UNITED STATES PATENT AND TRADEMARK OFFICE

| APPLICATION NO. | FILING DATE | FIRST NAMED INVENTOR | ATTORNEY DOCKET NO. | CONFIRMATION NO. |
|-----------------|-------------|-----------------------|---------------------|------------------|
| 10/027,203 | 12/26/2001 | James Richard O'Brien | 170933-1 | 1395 |

Office Action Summary

Fig 6 (Prior Art)

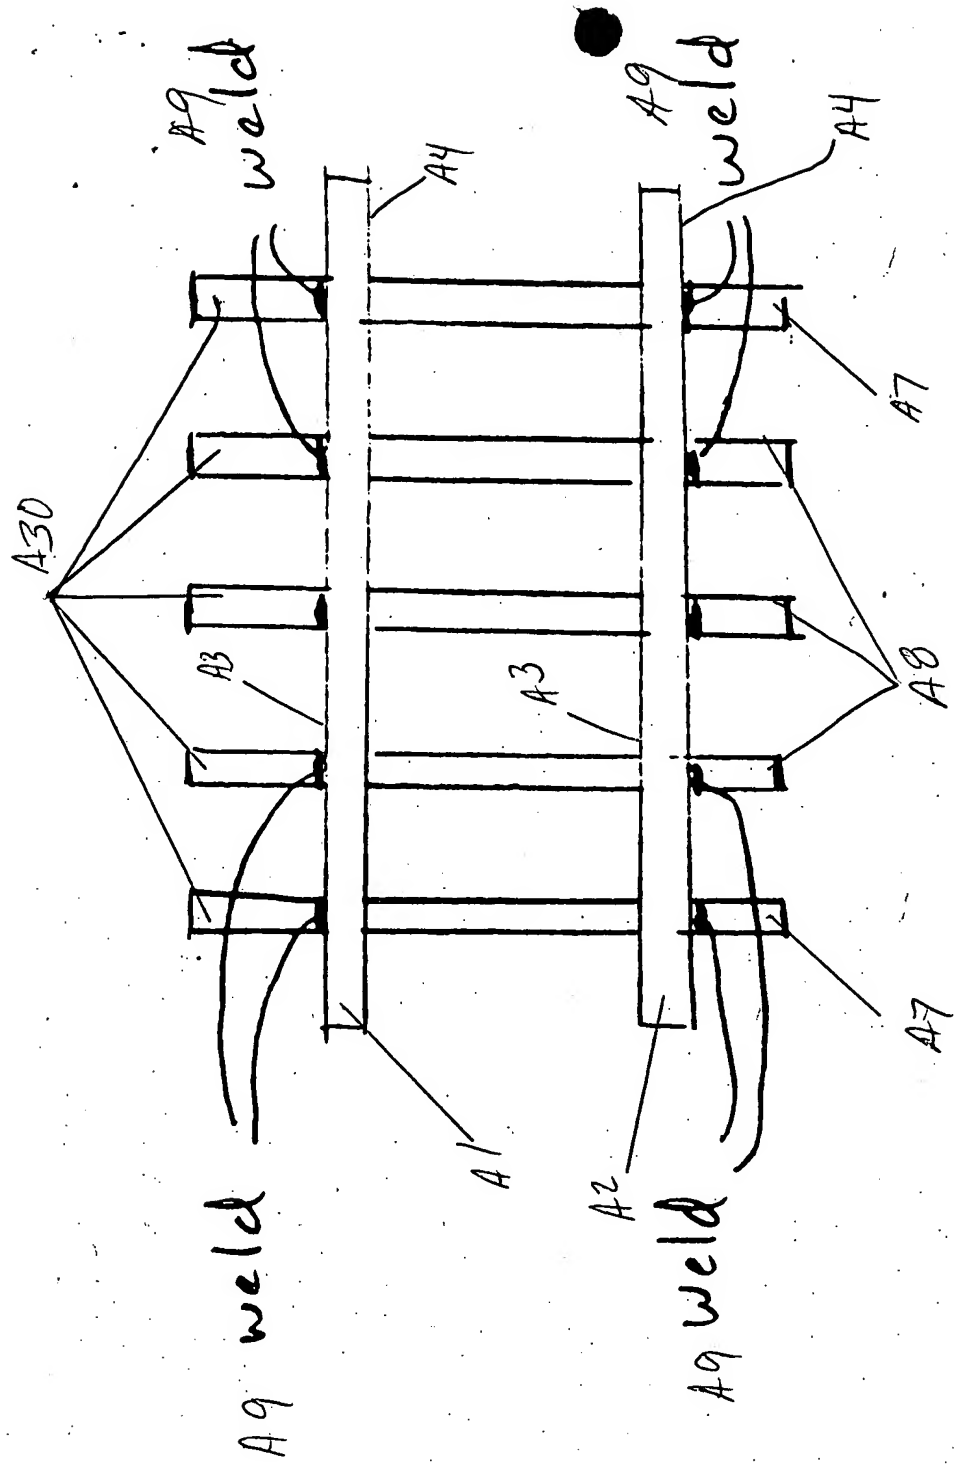
Claims 1, 10, 12-16 and 18 are rejected under 35 U.S.C. 103(a) as being unpatentable over applicant's admitted prior art (see marked-up attachment) in view of Costacurta, FR-1,061,340.

Regarding claims 1 and 12, Figure 6 of applicant's figure disclose a fence panel comprising a first rail **A1**, a second rail **A2**, spaced-apart pickets **A6**, and fasteners **A9**.

The first rail **A1** is disposed parallel and spaced-apart from the second rail **A2**. The first rail **A1** and the second rail **A2** define a longitudinal length of the fence panel,

an opposing first side edge **A3** and an opposing second side edge **A4**. The first rail **A1** and the second rail **A2** are disposed at an angle relative to horizontal.

The pickets **A6** define a pair of opposing outer pickets **A7** and inner pickets **A8**, and are disposed substantially perpendicular to horizontal. The inner pickets **A8** and the outer pickets **A7** are attached to the first rail **A1** and the second rail **A2**.

The fasteners **A9** are between the inner pickets **A8** and the first side edge **A3** of the first rail **A1** and between the inner pickets **A8** and the second side edge **A4** of the second rail **A2**.

However, the prior art fails to disclose the fasteners **A9** between the outer pickets **A7** and the second side edge **A4** of the first rail **A1** and between the outer pickets **A7** and the first side edge **15,16** of the second rail **26**. The French patent '340 teaches fasteners between the outer pickets **C** and a second side edge of a first rail **A** and between a first side edge of a second rail to fasten the outer pickets to the rails at intersections. Therefore, as taught by the French patent, it would have been obvious to one of ordinary skill in the art at the time the invention was made to include fasteners between the outer pickets and the second side edge of a first rail and the first side edge of the second rail to fasten the pickets to the rails.

Regarding claims 10 and 18, Figure 6 of applicant's figures shows the first rail **A1** and the second rail **A2** are four-wall tubular members.
